SUBMISSION TO THE INDEPENDENT EXPERT PANEL FOR MINING IN THE CATCHMENT

March 2019

This is WaterNSW's second submission to the Independent Expert Panel for Mining in the Catchment (the Panel), following a detailed submission in May 2018 which addressed the Panel's first Term of Reference. The Panel has since published its *Initial report on specific activities at the Metropolitan and Dendrobium coal mines* (the Initial Report).

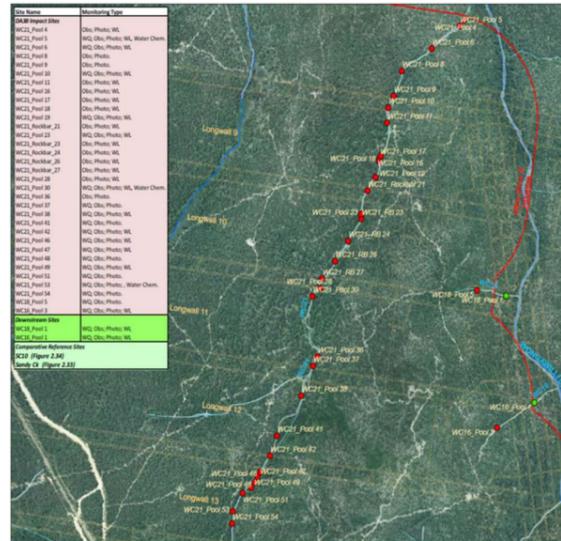
- Statistically significant changes in species composition at Swamp 15B observed since mining of LW8 in 2012.
- WaterNSW considers that the impacts on Swamps 12 and 15b (and associated watercourses SC10C and WC17) have exceeded EIS and SMP predictions.

- The vegetation changes at Swamp 15b indicate an impact on threatened ecological community Coastal Upland Swamp of the Sydney Basin Bioregion.
